SERVICE LETTER February 28-2005

This Service Letter is for up-dating the “closed” inside labels of the “gull wing door” handles, and general inspection of the handles / doors area.

The affected models are aircraft CH 2000 serial numbers 20-0002 and up.

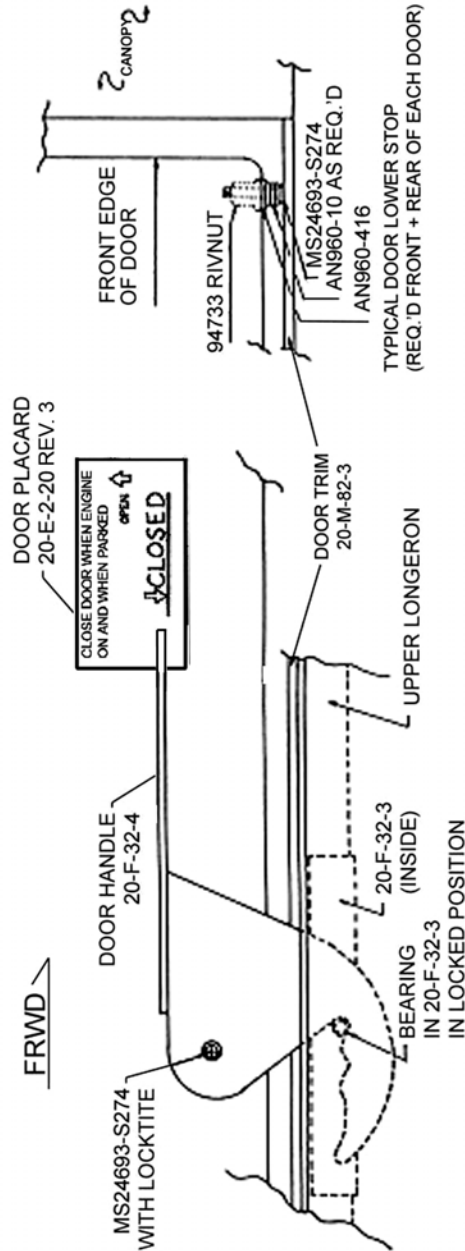
“Gull wing door” handle area inspection, as per schematic on page two of this Service Letter.

- Install label 20-E-2-20 REVISION 3 as per following schematic (on page two), as follows:
 - 1, Remove “Closed” label beside door handle inside door.
 - 2, From inside the aircraft, with the “gull wing doors” closed firmly, make sure that the door handle is parallel with the arm rest. Door handle **MUST** be pushed down all the way.
 - 3, Glue label 20-E-2-20 REVISION 3 with the “closed” line/down arrow, lined up with the handle. Note that there is a left and right label.
- Inspect the bearing in 20-F-32-3 and make sure that it is not worn-through, that it rotates freely and that it is greased.

- The schematic shows a 10-32 rivnut located front + rear of each door, with washers and countersunk screw. When the door handle is in the closed position, the front + rear countersunk screws must be tight against 20-M-82-3 (channel on top of Upper Longeron).
- Make sure that the door handle position is as per schematic in the “closed” position and that it has “positive locking pressure”.
- Make sure that handle screw MS24693-S274 is tight and that “locktite” has been applied.
